**ADDENDUM NO. 1**

**CITY OF SAN ANTONIO  
CAPITAL IMPROVEMENTS MANAGEMENT SERVICES**

**PROJECT NAME:  
EMERGENCY OPERATIONS CENTER SITE REVISIONS – PARKING LOT –  
40-00216**

**DATE: May 11, 2012**

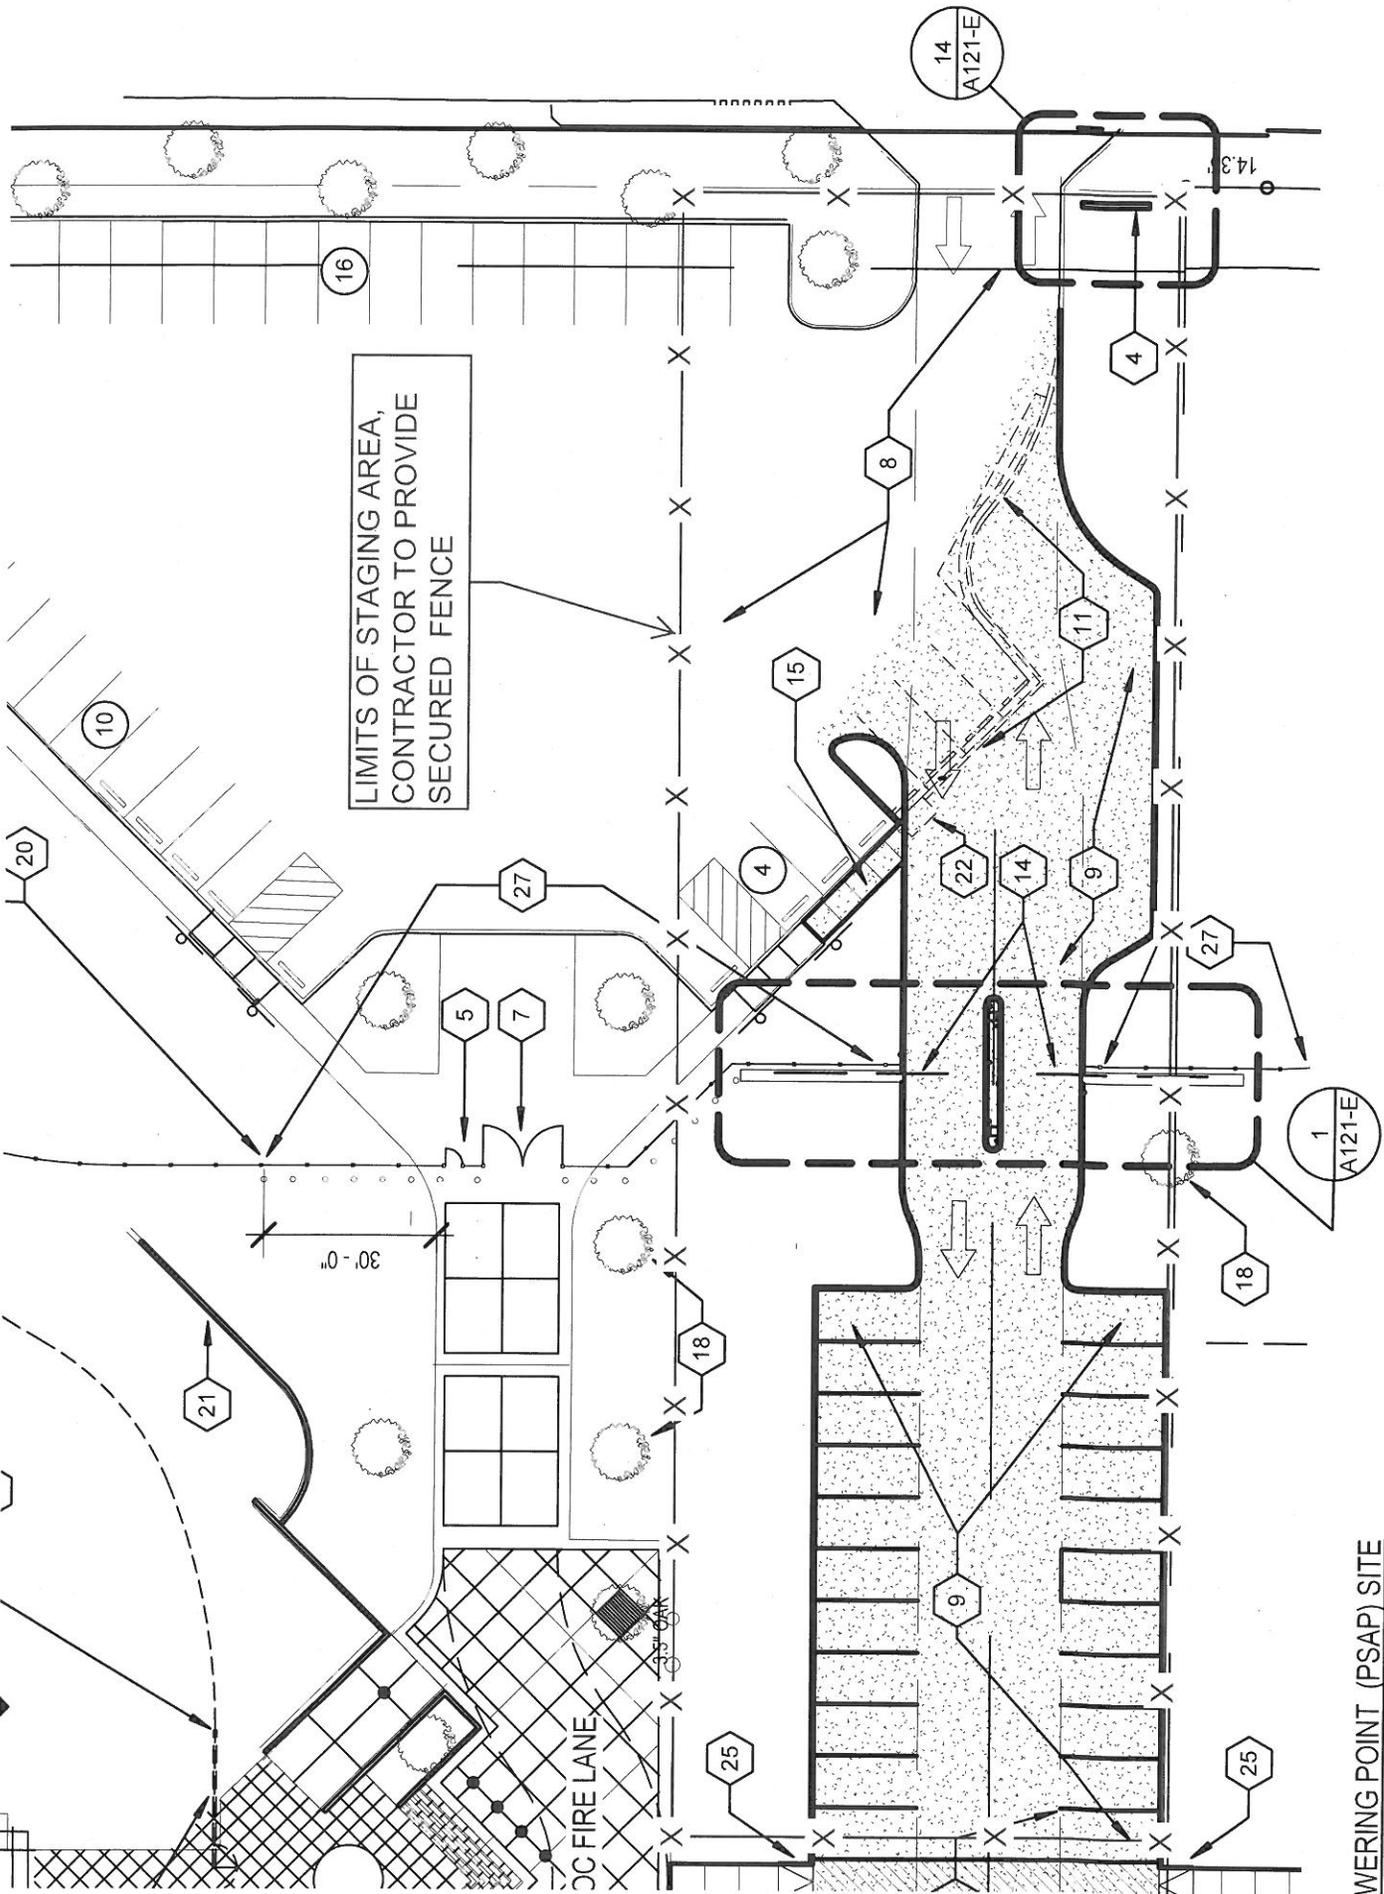
1.) At the South of the PSAP (911 Dispatch Center) property there is a 32' wide opening in the fence (4-8 panels) that will need to be closed after the completion of the EOC project. Currently this areas is to being used for PSAP vehicular access and will remain so until the completion of the project. The fence design and the spec is to match the existing fence on the PSAP property and is also to match the EOC fence that has a continuous 18" concrete curb (Note 1 on Sheet A101E). Concrete footing and curb are to be included along with removal of existing asphalt and providing a new concrete containment. Low emission vehicle signs will be provided by owner and are to be installed to match adjacent, (see attached sketch)

6.) See attached drawing for limited staging area. Vehicular access to each parking lot must be maintained. Owner is to be notified when access is limited. Any damage to the existing pavement is to be repaired.

SUNDT 911  
BOLLARD

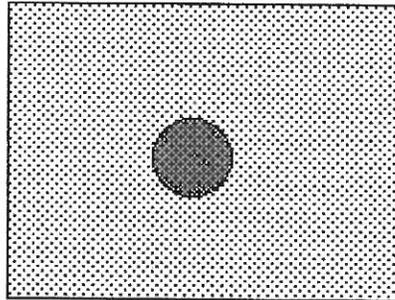
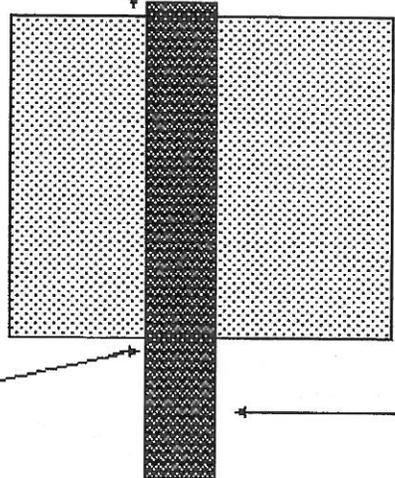
7.) See attached fence cable catch Bollard details. These details are in addition to the drawings.
